ACCESSION NBR: 8308230292 DOC. DATE: 83/08/19 NOTARIZED: NO DOCKET #
 FACIL: 50-388 Susquehanna Steam Electric Station, Unit 2, Pennsylvania 05000388
 AUTH. NAME: CURTIS, N.W. AUTHOR AFFILIATION: Pennsylvania Power & Light Co.
 RECIP. NAME: SCHWENCER, A. RECIPIENT AFFILIATION: Licensing Branch 2

SUBJECT: Forwards new to FSAR Chapter 18 reflecting responses to TMI items Chapter will be included in next FSAR amend.

SUSQUEHANNA STEAM ELECTRIC STATION
TMI RESPONSE FOR UNIT 2
ER 100508 FILE 841-1
PLA-1785

FIGURE 18.1-11

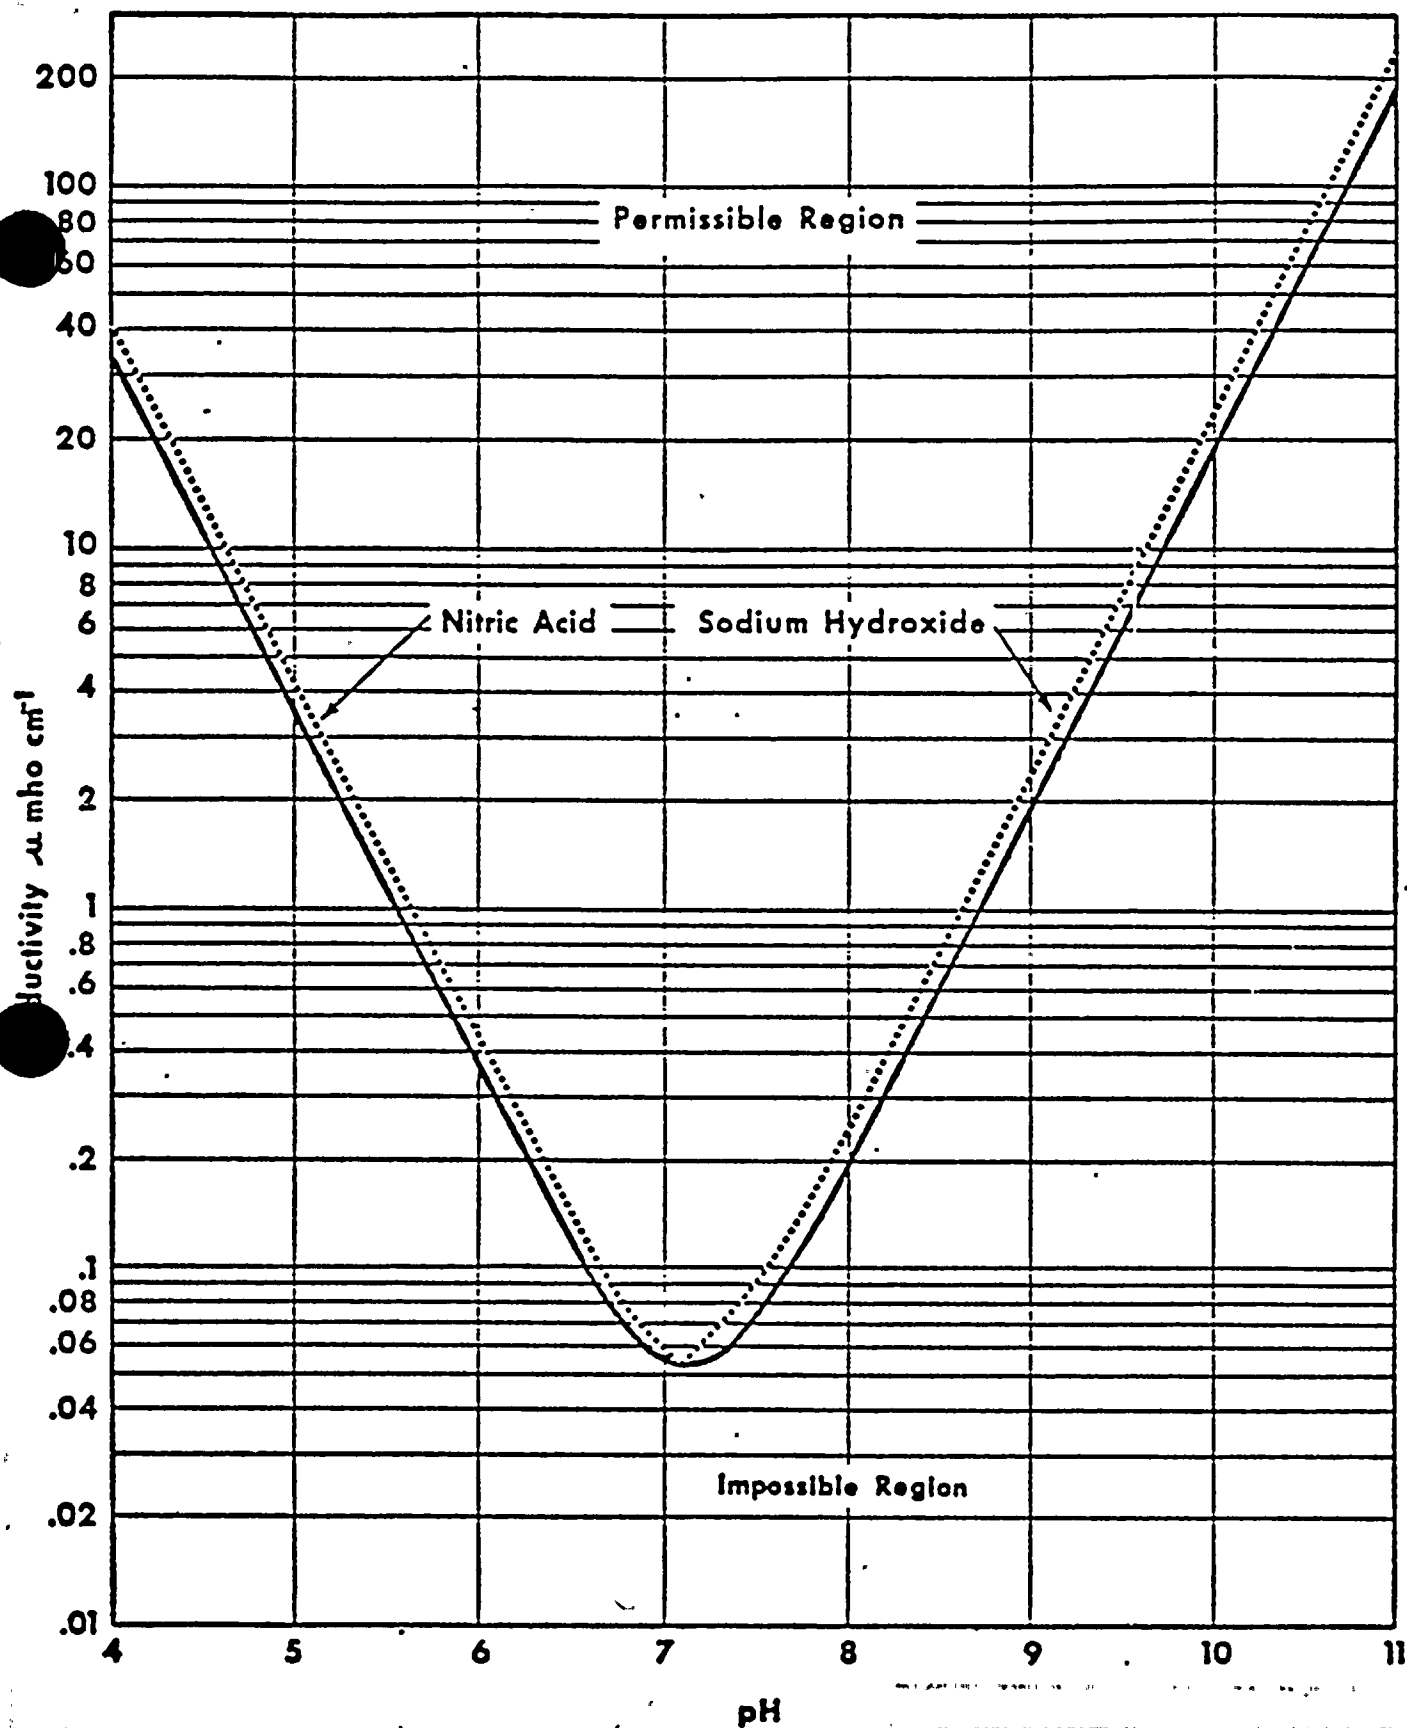
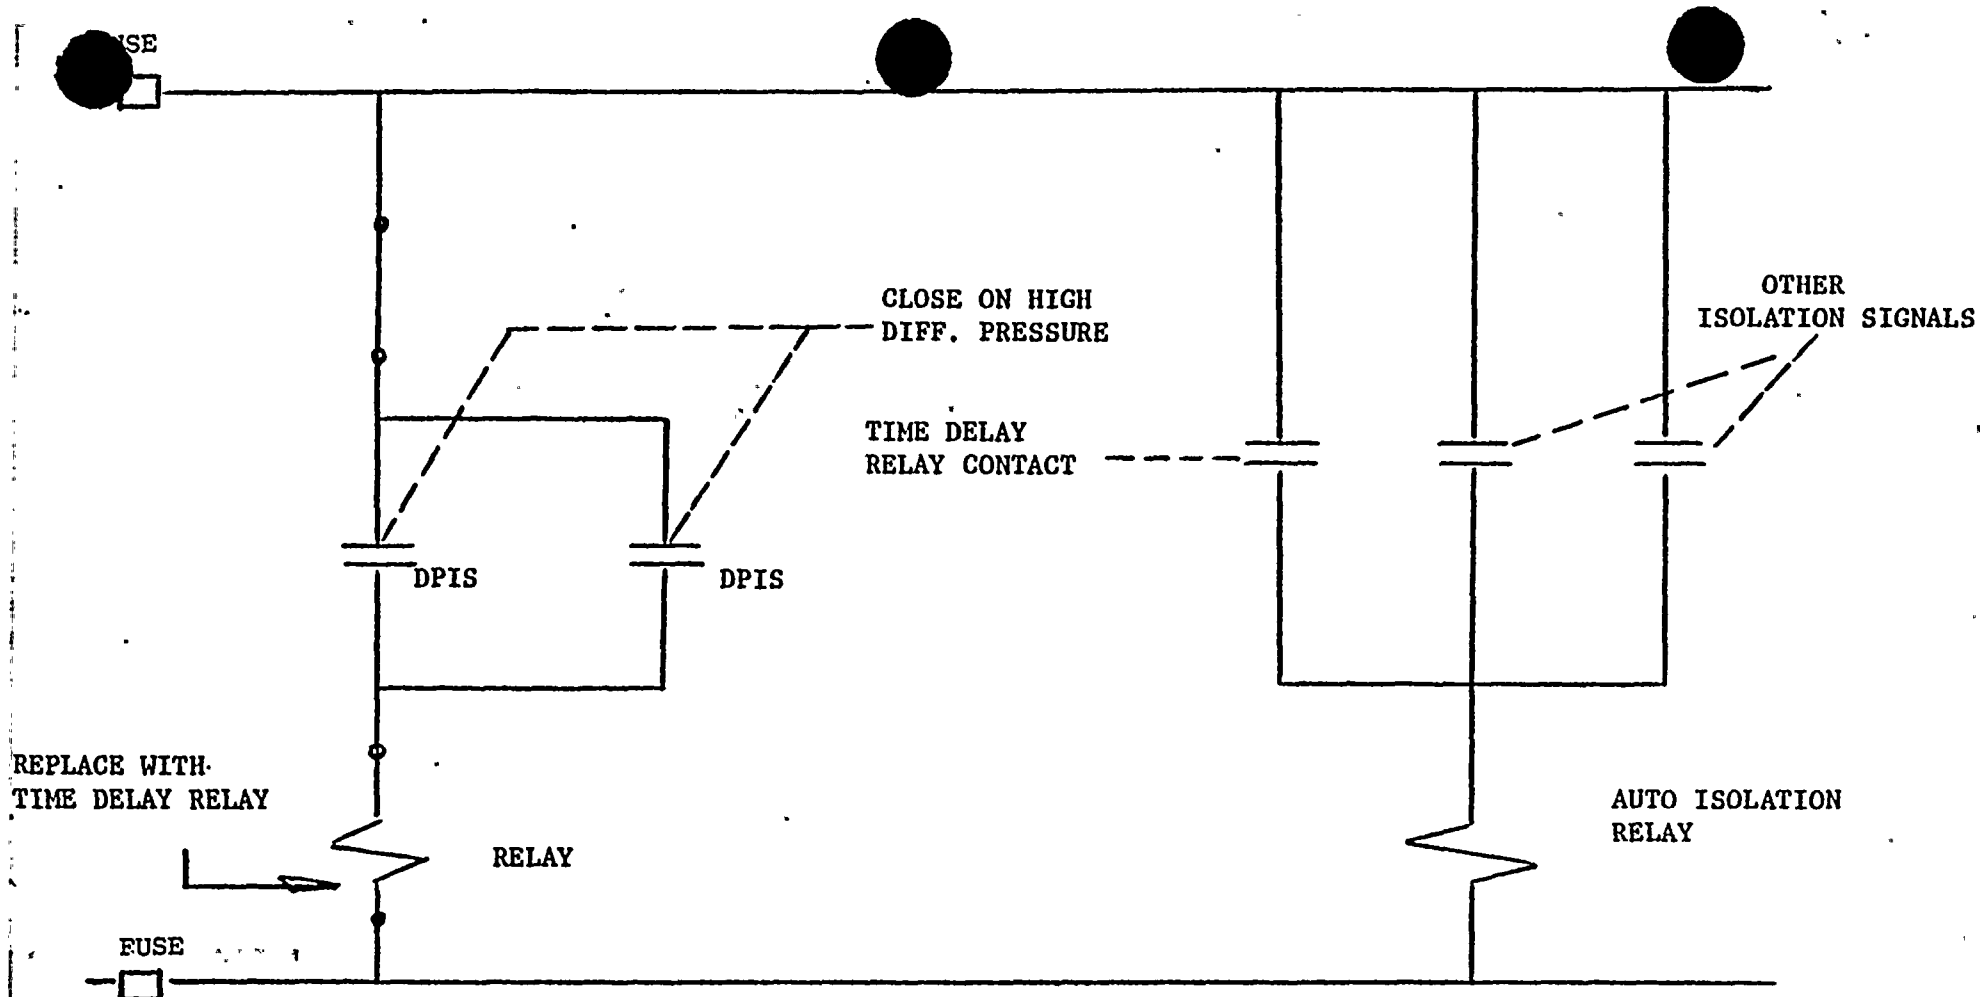
- Figure 18.1-14 - This figure titled "Specific Conductance of pH of Aqueous Solutions at 25°C" has been renumbered as Figure 18.1-11.
- Figure 18.1-15 - This figure titled "Typical HPCI/RCIC Steamline Break Detection Logic" has been renumbered as Figure 18.1-12.

FIGURE 18.1-13

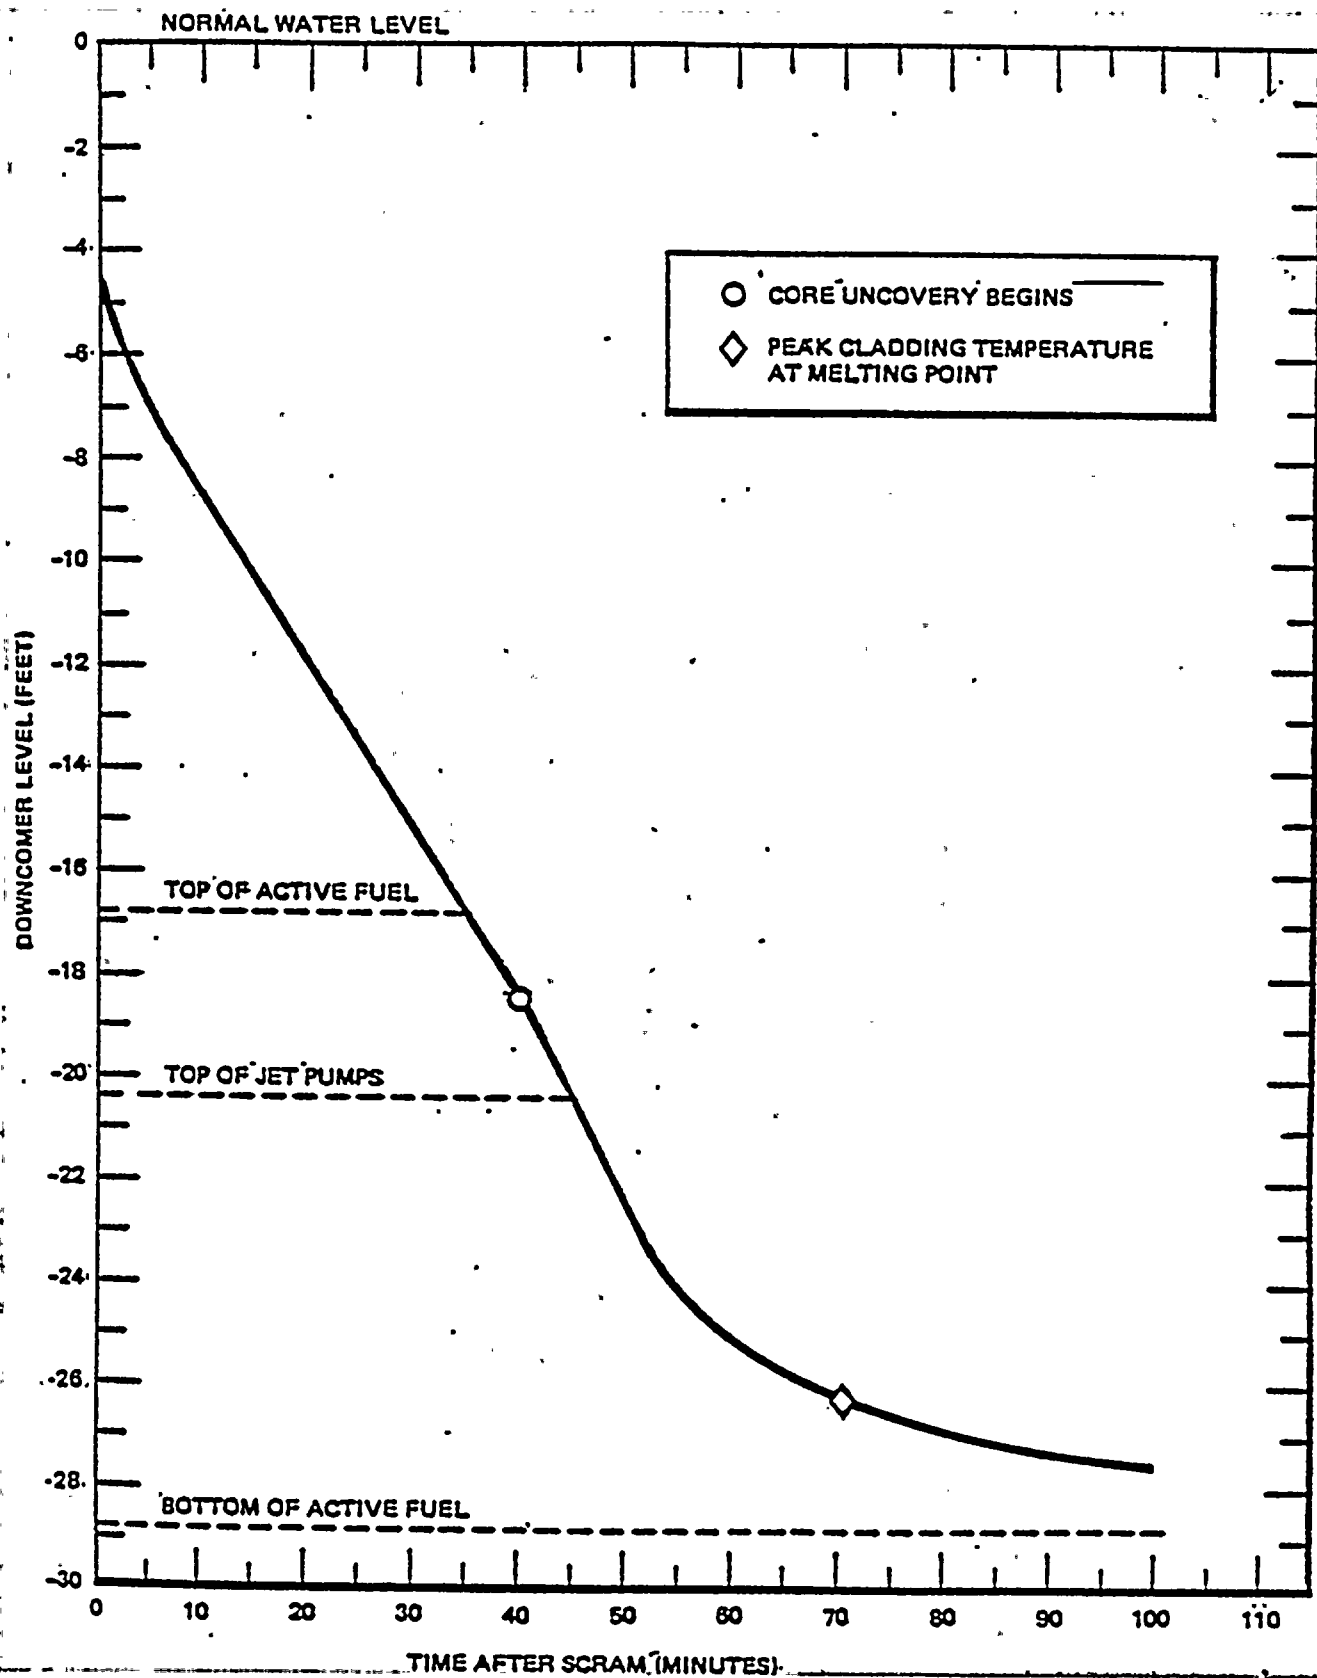
- Figure 18.1-16 - This figure titled "Typical Reactor Water Level Display" has been renumbered as Figure 18.1-13.
- - New Figure 18.1-14 titled "Downcomer Water Level History" has been added.

FIGURE 18.1-15

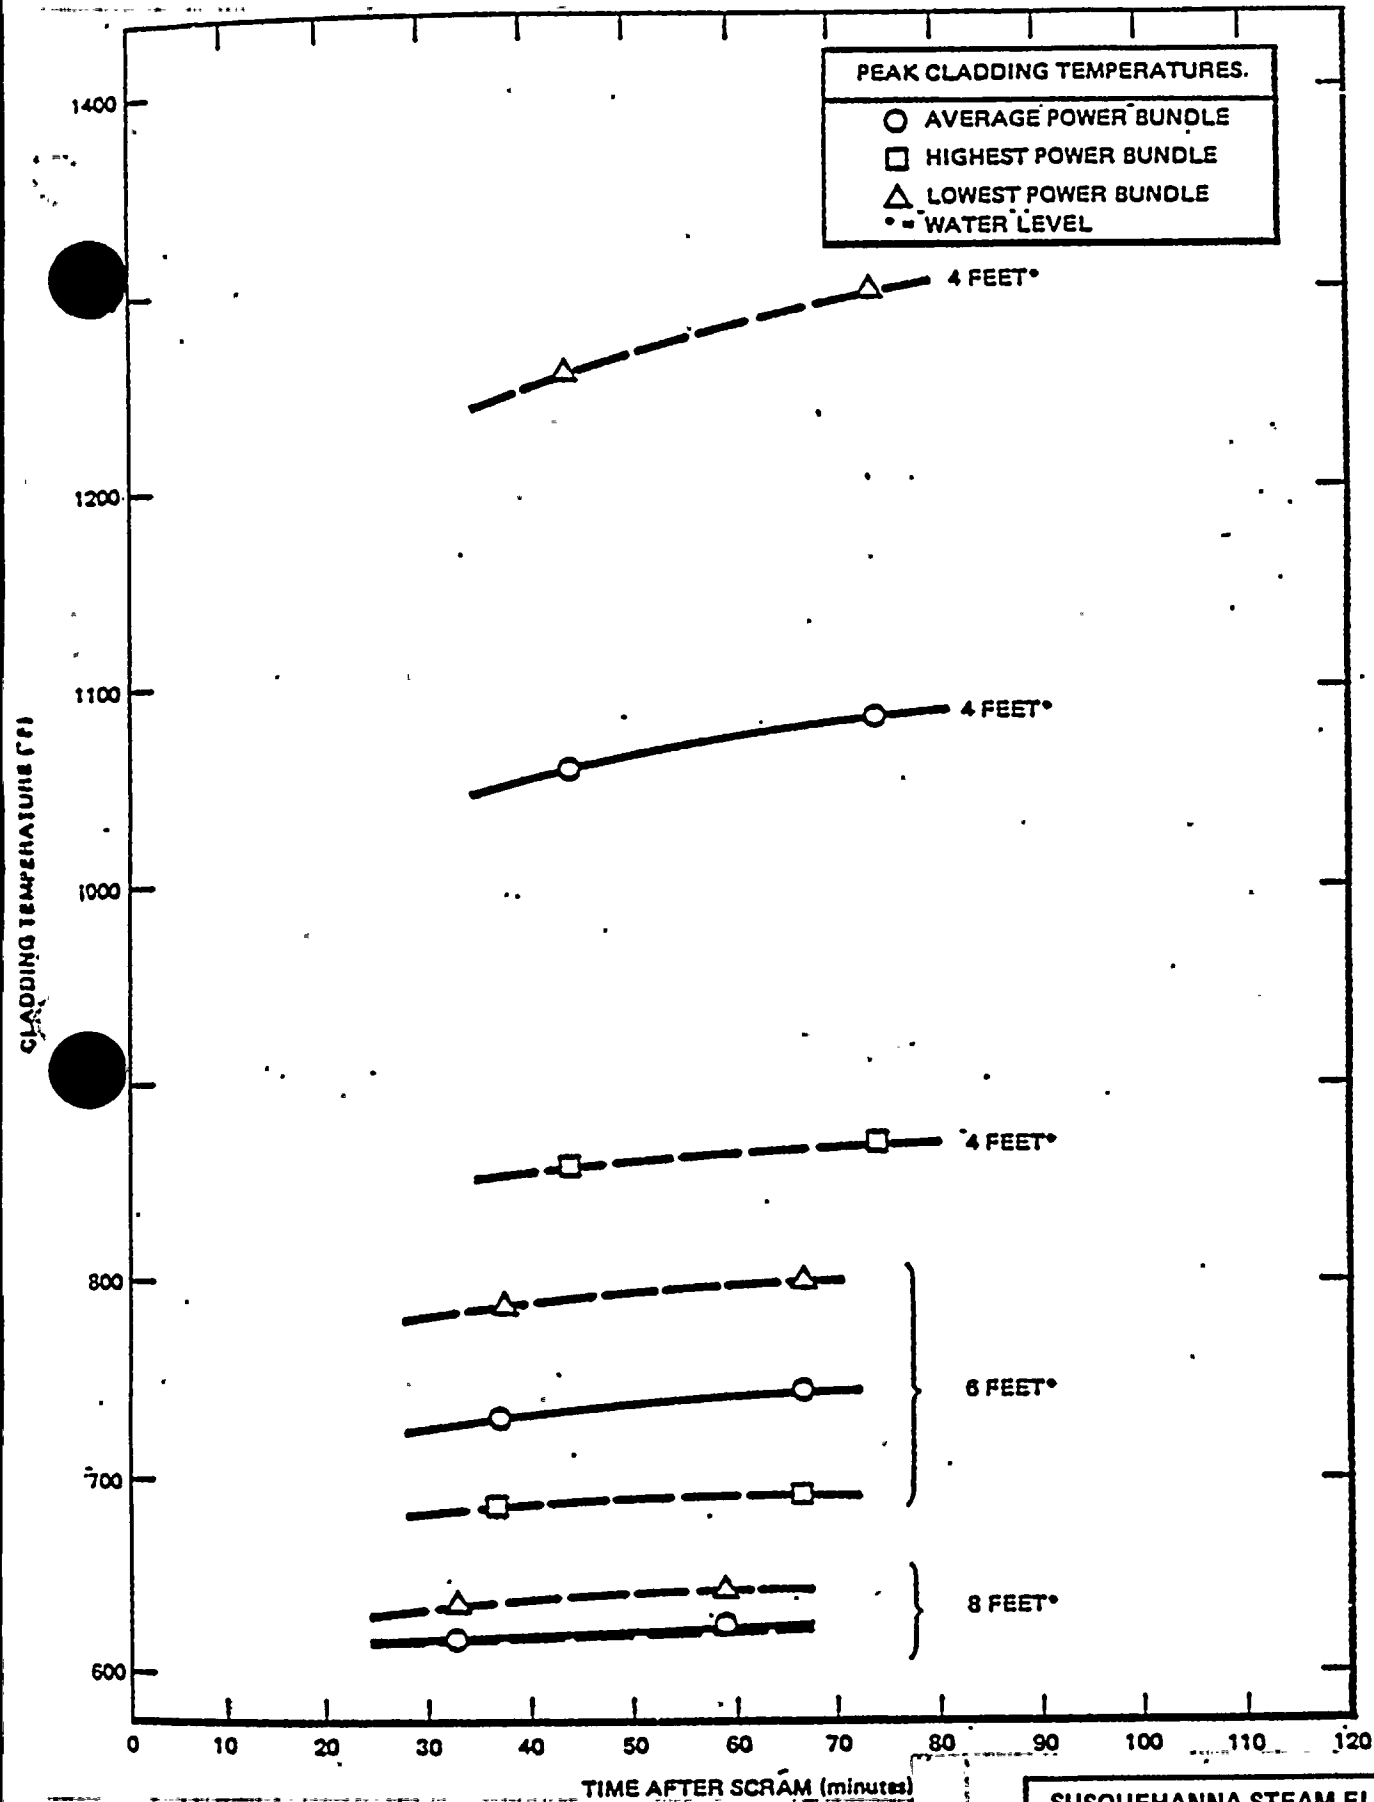
- - New Figure 18.1-15 titled "Water Level As An Indicator of Core Overheating" has been added.
 - - New Figure 18.1-16 titled "Cladding Temperature Sensitivity to Core Uncovery Time" has been added.
